Safety Recall

N242441390 Seatbelt Retractor May Lock

Revision: 02

Revision Description: This bulletin is being revised to update the service procedure. Please discard all previous copies of bulletin N242441390.

6682024

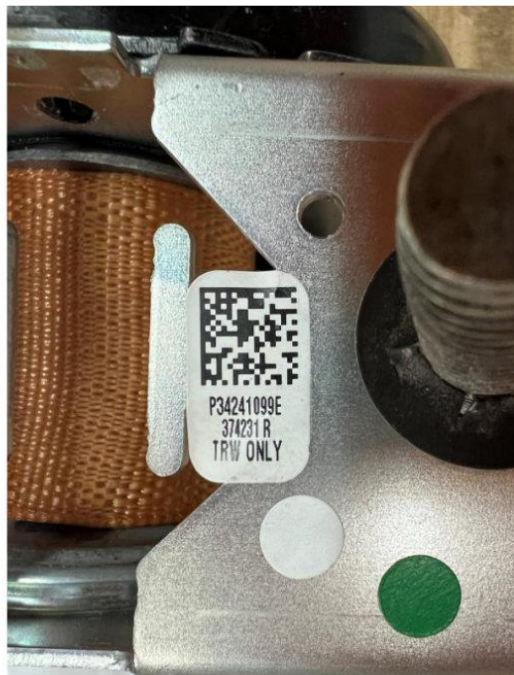
1. Inspect the NEW Seatbelt Retractor labels located on the bottom of the Seatbelt Retractor.
 - If the 4th and 5th digits are “23” AND the 1st and 2nd digits range between “35”-“52”, The part is BAD and MUST be scrapped. DO NOT INSTALL ON VEHICLE. Reference the Scrap Instructions below. Re-order a replacement Seatbelt Retractor and repeat inspection.
 - If the 4th and 5th digits are “23” AND the 1st and 2nd digits DO NOT range between “35”-“52” proceed to Step 3.
 - If the 4th and 5th digits are “24”, Proceed to Step 2.

6682025

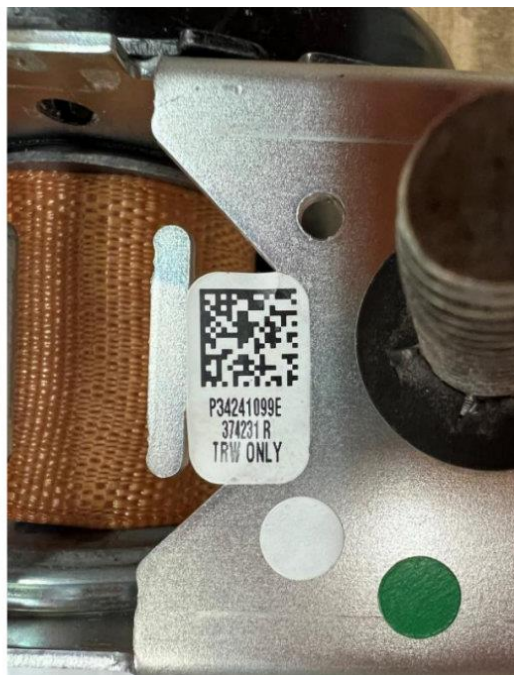
2. Continue to inspect the NEW Seatbelt Retractor labels located on the bottom of them retractor.
 - If the 4th and 5th digits are “24” AND the 1st and 2nd digits are “01”, The part is BAD and MUST be scrapped. DO NOT INSTALL ON VEHICLE. Reference the Scrap Instructions below. Re-order a replacement Seatbelt Retractor and repeat inspection.
 - If the 4th and 5th digits are “24” AND the 1st and 2nd digits are NOT “01” proceed to Step 3.
3. Replace BOTH the LH and RH Front Seat Belt Retractor. Refer to *Front Seat Belt Retractor Replacement* in SI. If convertible, refer to *Front Seat Belt Retractor Replacement - Right Side (Convertible)* and *Front Seat Belt Retractor Replacement - Left Side (Convertible)* in SI.
4. Scrap all replacement Seat Belt Retractors that failed inspection steps 1 and/or 2 AND the used Seatbelt Retractors. Refer to the Scrap instructions below.
